SUBJECT: COMANCHE PEAK NUCLEAR POWER PLANT, UNITS 3 AND 4  
DOCKET NUMBERS 52-034 AND 52-035  
RESPONSE TO REQUEST FOR ADDITIONAL INFORMATION NO. 5731  
(SECTION 19)

**RAI NO.: 5731 (CP RAI #218)**

**SRP SECTION: 19 - Probabilistic Risk Assessment and Severe Accident Evaluation**

**QUESTION NO.: 19-5**

Figure 1 - Variation of ICDP with Time

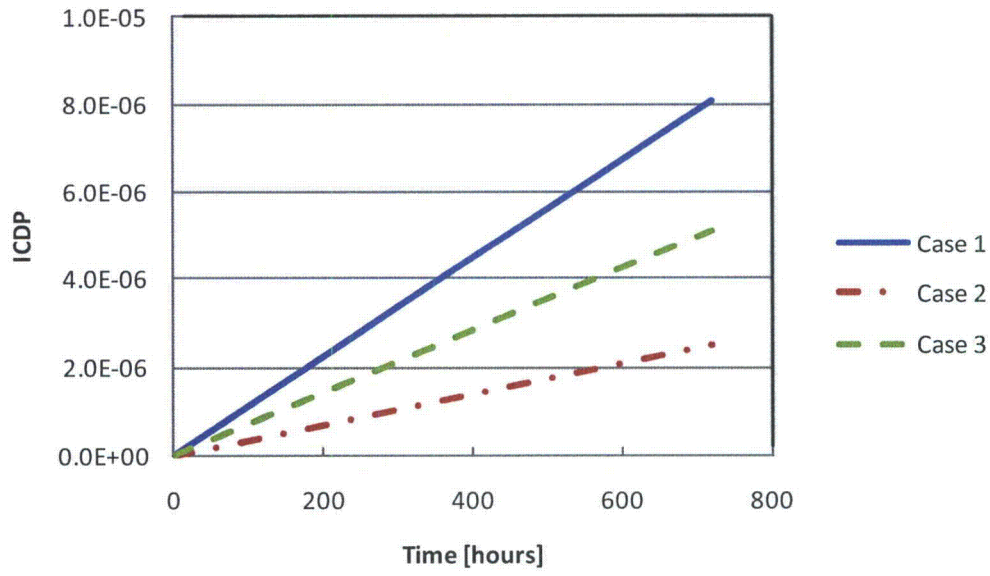
For each of the three cases please use the currently available PRA model to calculate risk-informed completion times (RICTs) and submit the results and associated discussion to NRC for the staff's review.

Please include a separate discussion for each case which includes the following: (1) major assumptions used in calculations and regarding risk management actions; (2) the calculated core damage frequency (CDF) and large release frequency (LRF) (or large early release frequency (LERF) increase versus time; (3) the calculated incremental core damage probability (ICDP) and ILERP versus time; (4) list of significant contributing cutsets to the increased risk (at least for CDF) with adjusted probabilities reflecting equipment outages (e.g., impact of equipment outages on baseline PRA common-cause failure probabilities and initiating event frequencies); (5) treatment of uncertainties in decision making.

The calculated time variations of ICDP and ILRP values are shown in Figures 1 and 2, respectively. The calculated ICDP and ILRP values at the time of reaching the 30-day backstop are  $8.1E-07/RY$  and  $6.5E-07/RY$ , respectively.

The calculated time variations of ICDP and ILRP values are show in Figures 1 and 2, respectively. The ILRP reaches the criterion of  $1E-06$  at 20 days after entering Condition A of LCO 3.8.1.

The calculated time variations of ICDP and ILRP values are show in Figures 1 and 2, respectively. The calculated ICDP and ILRP values at the time of reaching the 30-day backstop are  $5.1E-06$  and  $1.7E-07$ , respectively.
